Groundwater Transfer Review Summary Form

Transfer/PA # T- 14738

Application: T-14738

Applicant Name: J.R.S. Properties III LP

T-14738 - From Wells

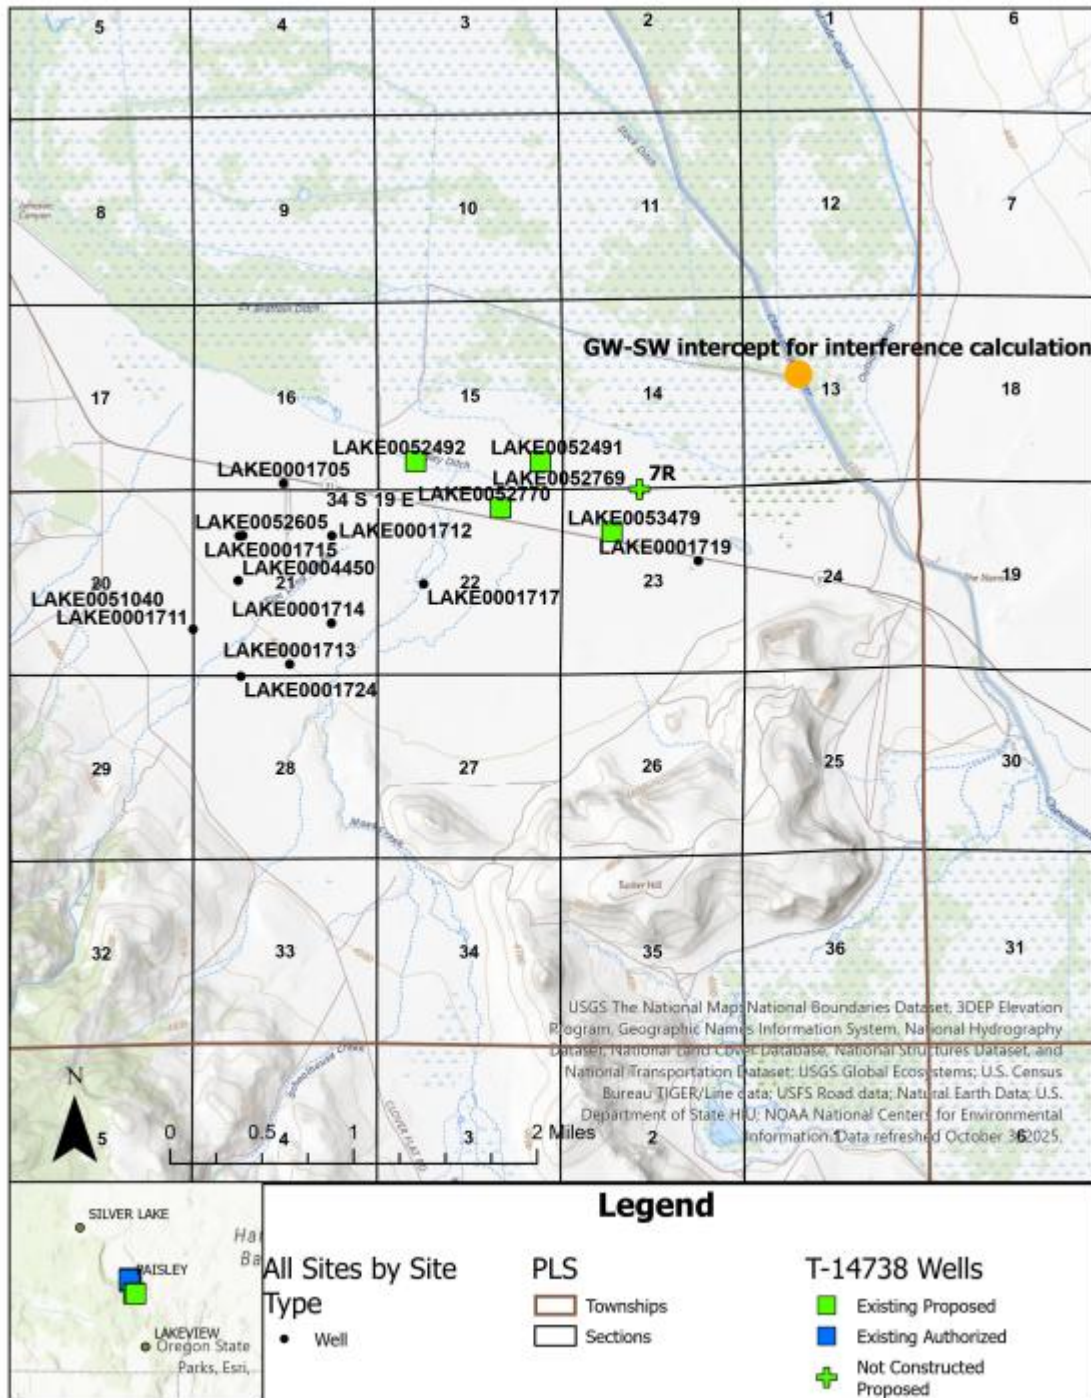
☒ Yes ☐ No Comments: The proposed change will move groundwater pumping about 6.8 to 8.8 mile south from the north side of Upper Chewaucan Marsh to the south side of Upper Chewaucan Marsh (see attached maps). The proposed change will move groundwater pumping closer to a different set of groundwater right wells (see attached maps).

Area Hydrographs**Reference Level Discussion Hydrographs**

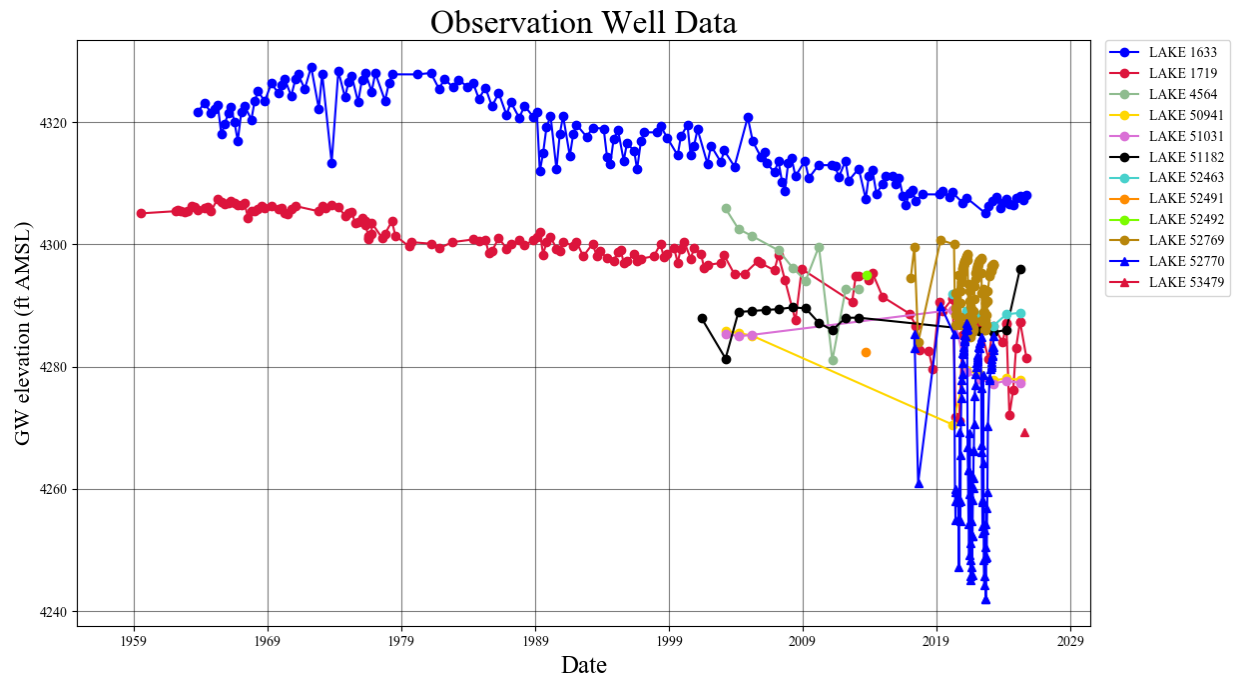
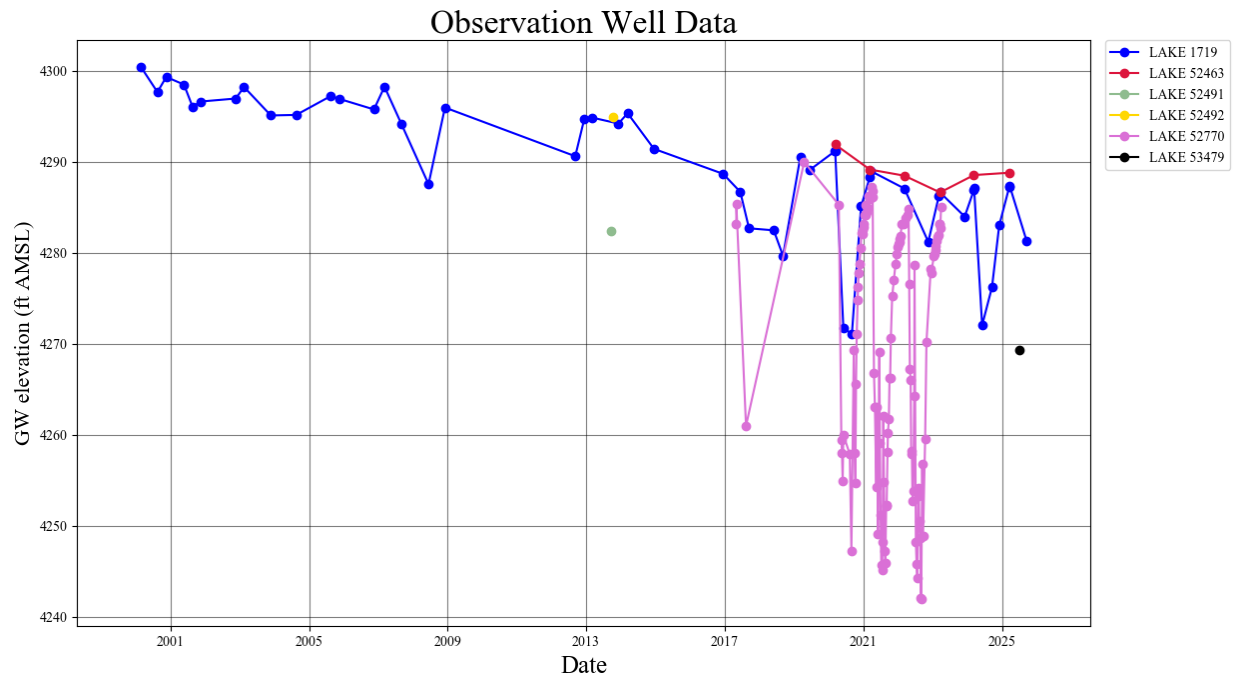
Additionally, the proposed change moves groundwater pumping into a vicinity that appears to be experiencing a groundwater level decline since 2005 (see attached hydrographs). The groundwater level at well LAKE 1719 is relatively stable, near 4302 feet elevation amsl from 1960 to the mid-1970s, a decline of about 5.5 feet from the mid-1970s to early 1980s to a new equilibrium of about 4297 feet elevation amsl that is close to the Chewaucan River stage near the Narrows (relatively steady from about 1980 to 2005), and an ongoing decline since 2005, possibly taking the groundwater level below the river bottom. The groundwater level decline in the 1970s and after 2010 may correspond to increased groundwater development in the area.

The applicant has submitted 2017 to 2023 data (see hydrographs) for wells LAKE 52769 [60 feet total depth], and LAKE 52770 [1,100 feet total depth], and LAKE 52463 [410 feet total depth]. The data can be interpreted as showing an annual decline like LAKE 1719 which has experienced a total groundwater level decline of 20.2 feet over the period of record.

LAKE 52491 and LAKE 52492 were installed in 2013, however, March groundwater levels have not been collected despite these wells being listed under temporary transfer T-13524. No groundwater levels are available from LAKE 53479 other than at time of well completion in July of 2025. Given the lack of water level data for these wells, it is not possible to make well specific evaluations regarding extrapolating reference levels. However, given that data available from LAKE 1719, LAKE 52770 and LAKE 52463 suggest similar groundwater levels and trends despite differing construction, it is likely that the other "From" POAs listed on this transfer would also show similar groundwater levels and trends (See attached "Reference Level Discussion Hydrographs").

The water level in LAKE 1719 was 19.84 bls (4298.22 ft amsl) on 2/14/2003 which is the same year that the reference levels were established for the “From” POA under Certificate 93777. Groundwater elevations measured in LAKE 52770 are several feet lower than water levels measured at roughly the same time in LAKE 1719 during March. Taking this elevation difference into consideration, a water level elevation of 4295 ft amsl is likely a reasonable estimation of water level in LAKE 52770 in March of 2003. The ground surface elevation at the location (as shown on the transfer application map and in GWIS) of LAKE 52770 as determined by LiDAR is 4329 ft amsl. Using a reference level elevation of 4295 ft amsl results in a reference level of 34 feet bls for LAKE 52770. This same reasoning was used to establish reference levels for the other wells listed on this transfer. See the below table for a summary of these reference levels:

POA #	Well Log ID	2003 Water Level Reference Elevation (amsl)	Land Surface Elevation at Well Location (amsl)	Permit Condition Reference Level (bls)
7R	Not constructed	4295	4315	20
8	LAKE 52491	4295	4320	25
9	LAKE 52592	4295	4329	34
10	LAKE 52770	4295	4329	34
11	LAKE 53479	4295	4319	24
